SENENICH PROPELLER CO., INC.

SERVICE BULLETIN SB2016-06

SUBJECT: Inspection of adjustable pitch jabiru hubs for cracks

Figure 1. Cracks start near pitch marks and grow outwards.

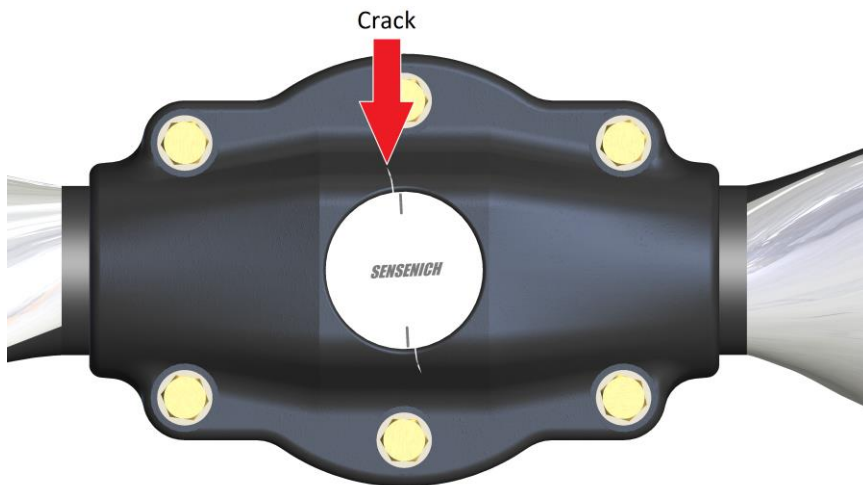
REASON: Sensenich has received reports of cracked hub covers on several tractor and pusher installations with Jabiru engines.

- The occurrence, if unattended, could result in the hub cover half cracking completely across.
- To date, there have been no inflight blade separations but the location of crack growth necessitates immediate inspection.

- Inspect hub for cracks before next flight.
- Remove spinner dome (and front bulkhead, if used). Closely inspect the hub cover (clamp half) around the pitch cylinder and on the hub sides. Also examine the sides of the hub mount half. See Figures 1 and 2.
- Notify Sensenich of any crack occurrences and return hub for evaluation.
- Inspect hub for cracks every 50 hours or annually.
